# City of Alexandria, Virginia

## MEMORANDUM

**SUBJECT:** CONCEPT REVIEW OF 1604-1614 KING STREET (KING STREET  
GATEWAY), BAR CASE # 2014-0129

### Figure 2: Site plan

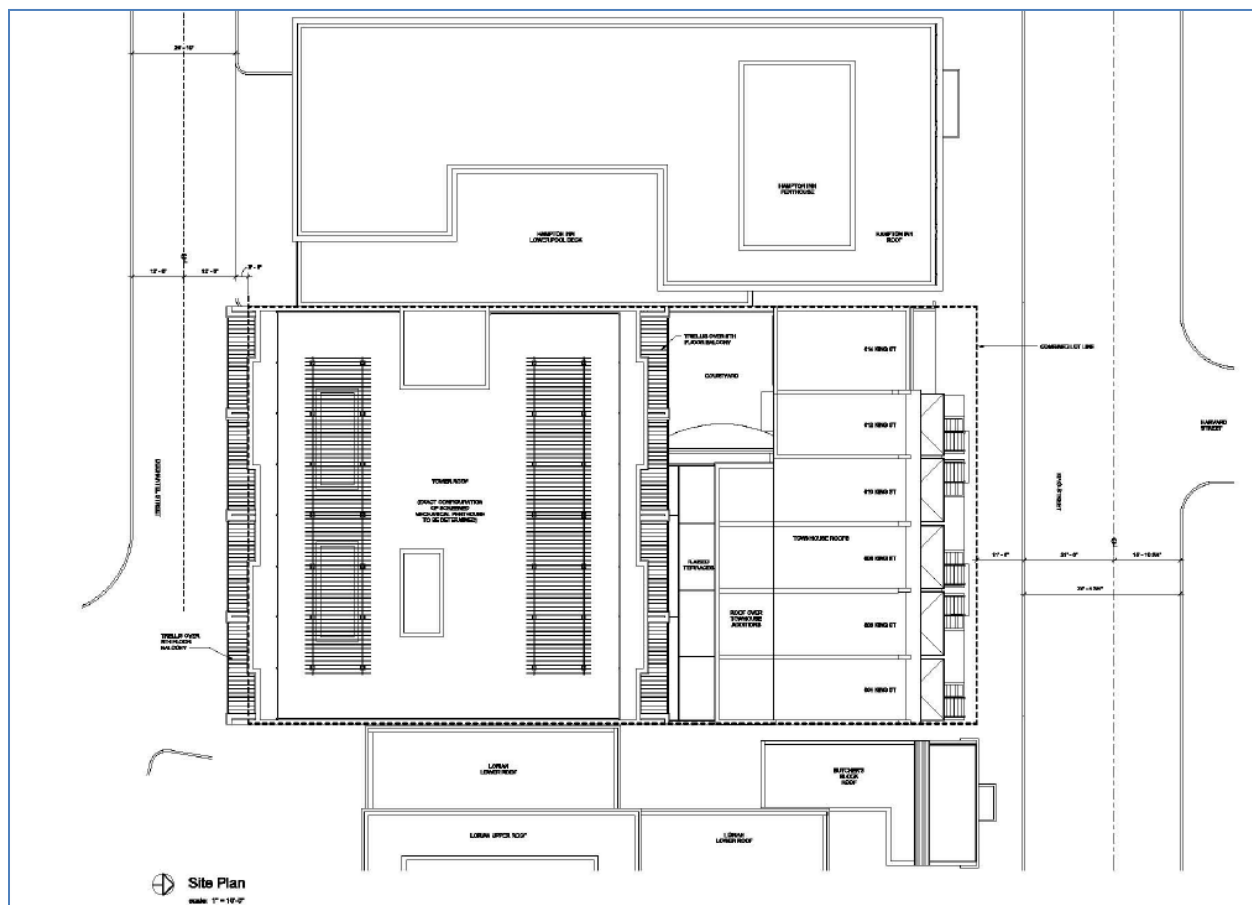
However, Staff does support the concept of demolition of portions of the first floor of 1614 King in order to create a covered pedestrian arcade to provide access the proposed building in the rear. Preservation of the façade and second floor use will help to retain the pedestrian scale along this portion of King Street and provide an inviting entrance to the courtyard for residents and guests. Staff also supports the applicant's proposal to demolish the rear ells on the townhouses. These have been altered since their original construction and the Board generally allows substantial alteration to these service ells on other projects. They will not be visible from the public right-of-way after the construction of the new residential building.

Figure 12: Height/view study

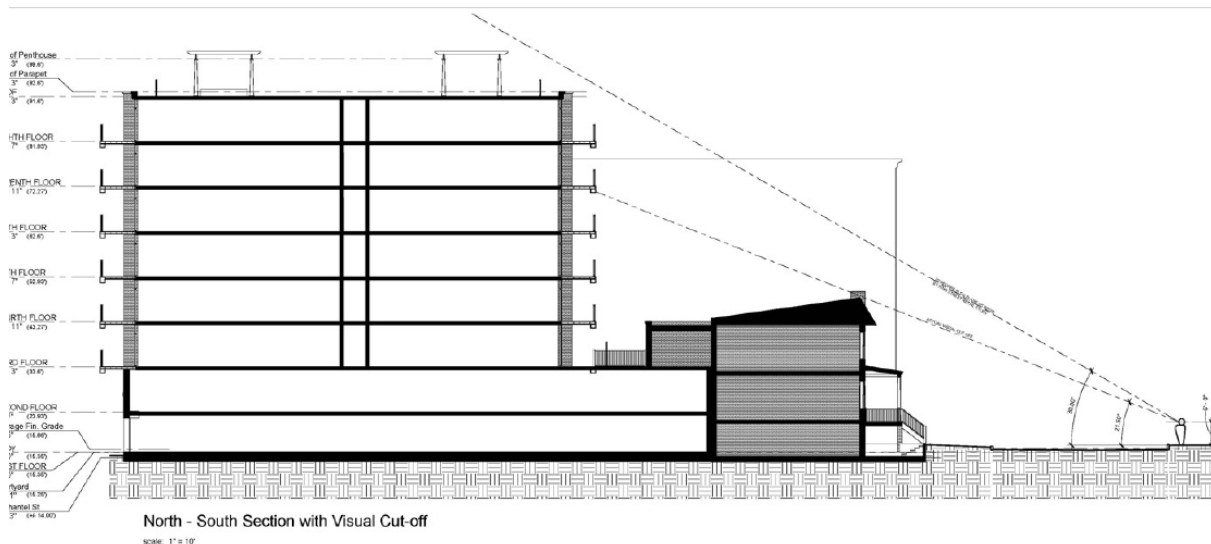
The applicant is looking for the Board's feedback on what architectural character would be most appropriate at this location. Although the applicant will show the Board six alternatives, the brick and glass building itself changes very little and the alternatives are limited to the skin and rooftop treatment (figures 6-11). Keep in mind that even though the height of the proposed building is taller than the adjacent hotels, the location of the tower at the back of the site and behind the townhouses makes visibility of the building more limited (figure 7). Staff believes that the more simple and straightforward designs with less embellishment would be the most appropriate in the location, especially given the architecture of the surrounding buildings. Staff has no objection to an 8 story brick building with a flat roof and a significant amount of glazing.
